## Site Specific Flood Risk Assessment

Dundrum Central  
Development

Document No: 20.170 - FRA – PL5

### 1.3 DLRCC REPORT OF THE CHIEF EXECUTIVE, 9TH OF JULY 2021, ON THE PAC SUBMISSION TO THE BORD

Fig 7. Dundrum Central Site Proposed SW Catchment Areas

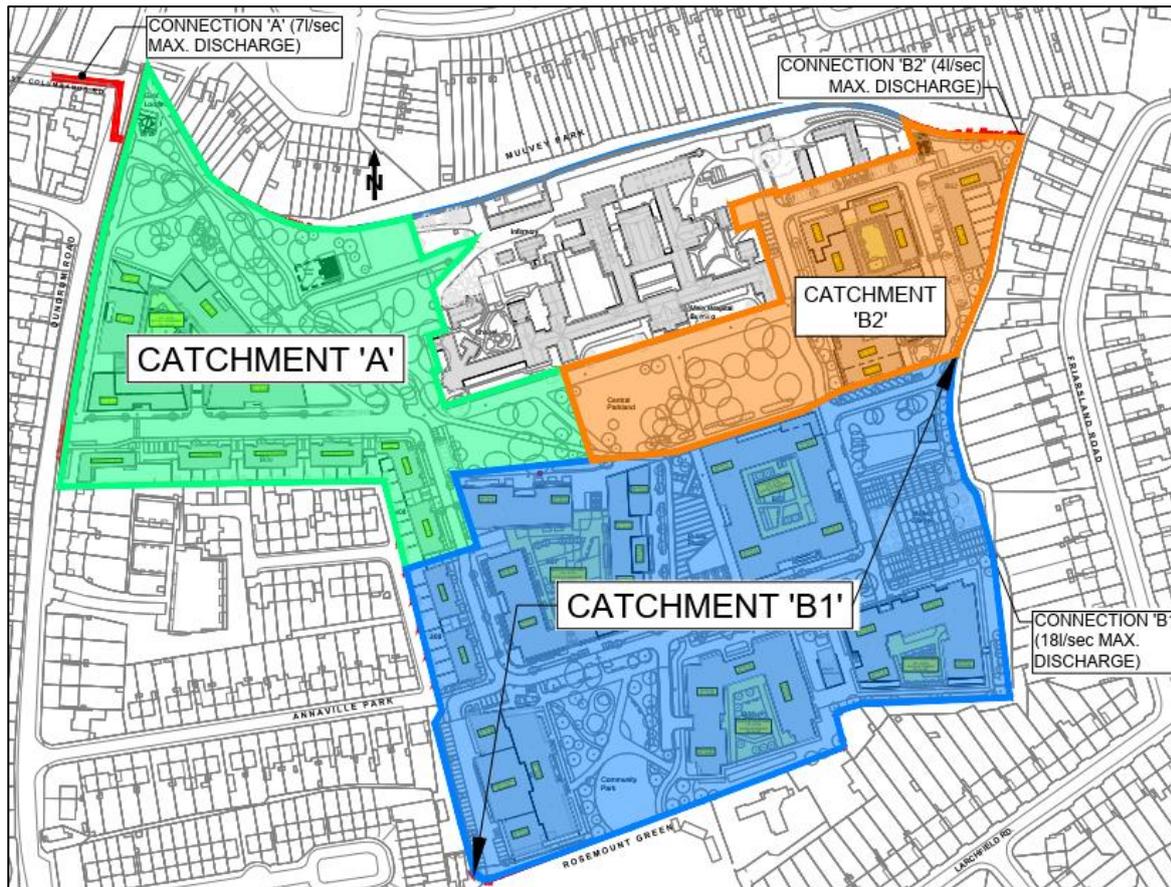
1. *The applicant has proposed to discharge 18 l/s to the Dundrum Slang instead of the greenfield runoff of 10 l/s. If possible, the applicant should discharge only 10 l/s to the Dundrum Slang, and direct the remaining discharge to another outfall from the site.*

Response: The west side of the proposed development site, which drains towards the River Slang, has greenfield runoff of 10 l/s. The revised drainage design has reduced the discharge to the Dundrum Slang down to a figure of 7 l/s. Therefore, the proposed development will not increase the predicted 1% AEP flow in the River Slang. See Section 3.2.3 of this report for more information.

The greenfield run-off rate  $Q_{bar}$  for Natural Catchment Area 1 (see Figure 4) is estimated to be 10 l/s. SW drainage flow from the proposed development is controlled and attenuated so as to not exceed  $Q_{bar}$  values. The max flow into the River Slang from the proposed development Catchment 'A' (see figure 7) for a 100 year storm + 20% cc is 7 l/s, which is less than the  $Q_{bar}$  for Natural Catchment Area 1 (figures obtained from the Infrastructure Report accompanying this application). The predicted 1% AEP flow in the River Slang is 8600 l/s or 8.6m<sup>3</sup>/s, the proposed development will reduce this by 3 l/s.

Fig 8. Controlled overland Flow Routes in the event of a Surface Water drainage blockage  
(Extracted from BM drg no. c1025 – See Appendix 4)

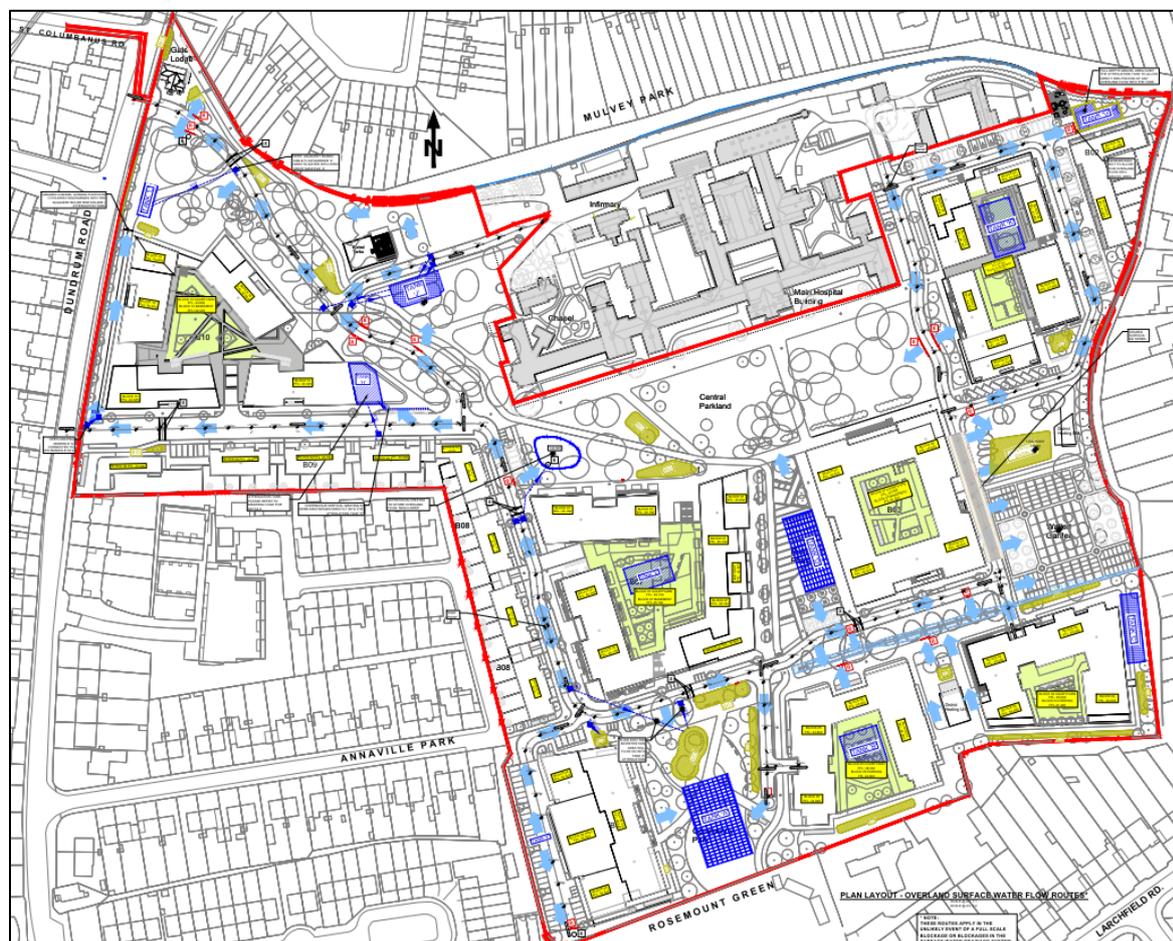
2. *It is acknowledged that the applicant has submitted a SSFRA Which discusses how overland flows Will be dealt with both within and adjacent to the site. However, they have not provided a drawing to demonstrate this, The applicant is requested to submit a drawing identifying and showing details Of safe overland flow routes both within and Without the site. The overland flow route plan should identify drop kerbs or ramps requested for channeling the flow, should address low point areas in the site and should detail how properties, both within the development and on adjacent lands, will be protected in the event of excessive overland flows.*

3. *The applicant is requested to demonstrate how the proposed overland flow storage areas will operate during such an event.*

Response: A drawing dealing with overland flows has been prepared and is part of the planning application package. Barrett Mahony drg no. C1025. Refer to Section 3.4.4.1 of this report for a drawing extract & further information on the controlled handling of overland flows proposed in the site.

The overland flows are typically directed to attenuation tanks and the detention basin, by-passing the main buried drainage system. These SuDS features are designed for a 100 year storm + 20% climate change. Flow is also directed into the considerable areas of green space on site where infiltration & storage can take place augmented by the proposed addition of soakaways provided to cater for the unlikely event of an overland flow. Overland flow will occur along kerbed road. Kerb beak-outs and grated manholes are provided to re-direct flows, should they occur. Overland flow on to the Dundrum Road (and possibly the River Slang) are prevented.

impermeable surfaces from any surcharging manhole will be channelled along kerbed edges to break outs in the kerb and into existing attenuation tanks or other SuDS features as shown on Barrett Mahony drg no. C1025. An extract from this is shown below in Figure 8. Overland flows are therefore contained within the site in a controlled manner without risk to the residential buildings on site.
